## ACTION TRANSMITTAL No. 2018-09

**SUBJECT:** Scope Change Request for West St. Paul's Oakdale Avenue Multiuse Trail Project (SP # 173-020-016)

**SCOPE CHANGE REQUEST**  
**West St. Paul Oakdale and Marie Trail Extension**  
**City Project 18-4**  
**West St. Paul and Dakota County, Minnesota**

# FIGURE 1

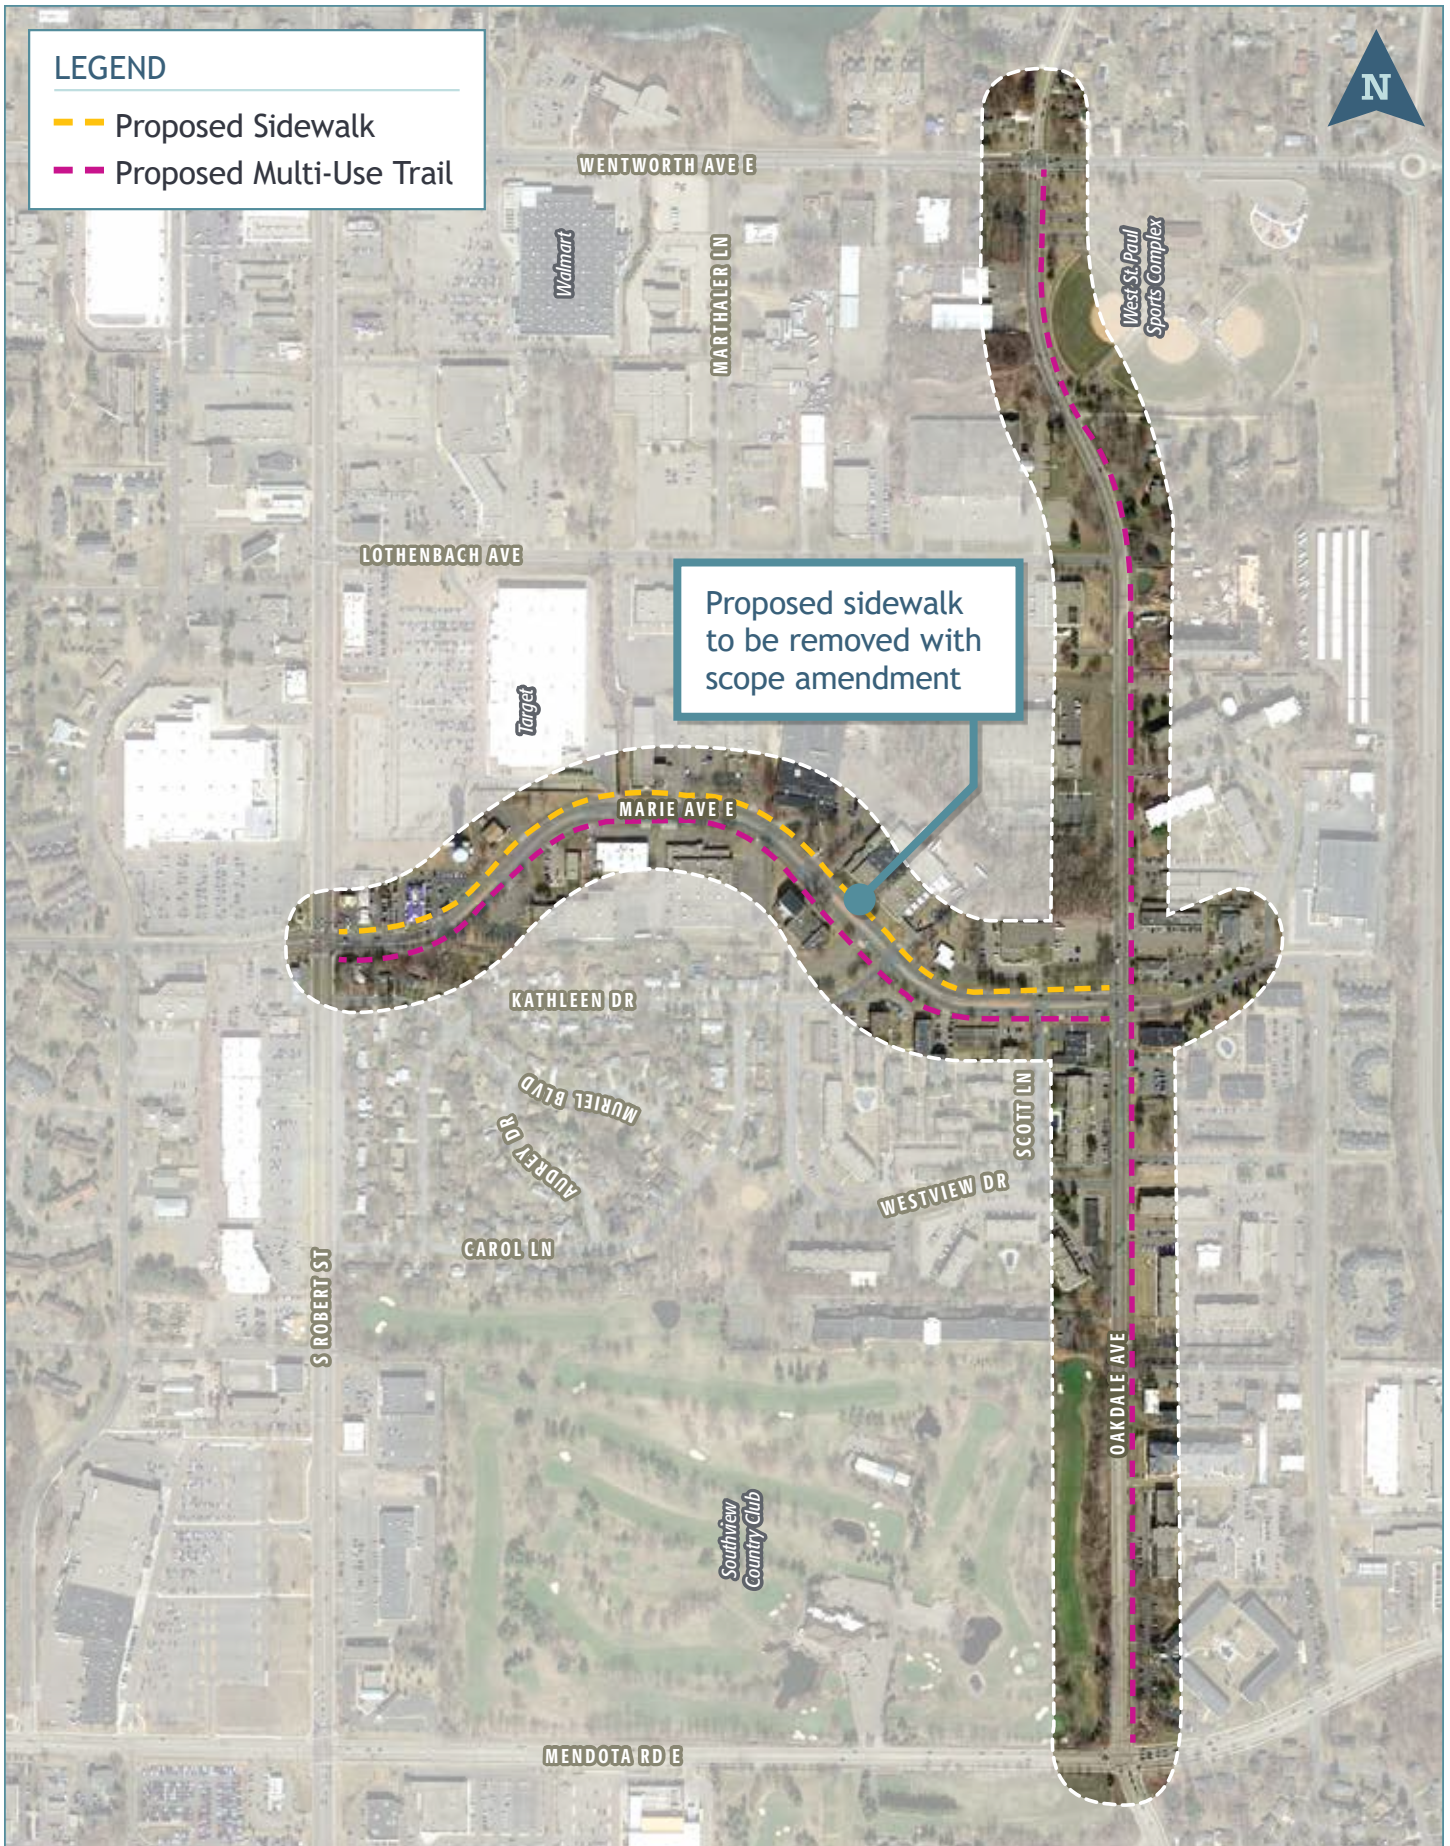
The City of West St. Paul received a Transportation Alternative Program (TAP) grant in 2017 to construct a multiuse trail along Oakdale Avenue (CR 73) from Mendota Road to Wentworth Avenue (CR 8) and both a multi-use trail and sidewalk along Marie Avenue from Robert Street (TH 3) to Oakdale Avenue (CR 73) (**See Figure 1**). The funding is in the 2018 – 2021 Transportation Improvement Program in the amount of \$1,494,200 (\$1,195,360 FHWA). The purpose of this letter is to request a scope change (including a funding change) for the project.

The scope change is the removal of the sidewalk along Marie Avenue from Robert Street (TH 3) to Oakdale Avenue (CR 73). The City is currently in the preliminary design phase of the project and has evaluated the estimated project costs in further detail. At the time of the application, no retaining wall costs or right-of-way acquisition costs were anticipated for the construction of the multi-use trail and sidewalk along Marie Avenue. It has been determined through the preliminary design process that both right-of-way acquisition and retaining wall construction will be necessary for the trail and sidewalk to be constructed.
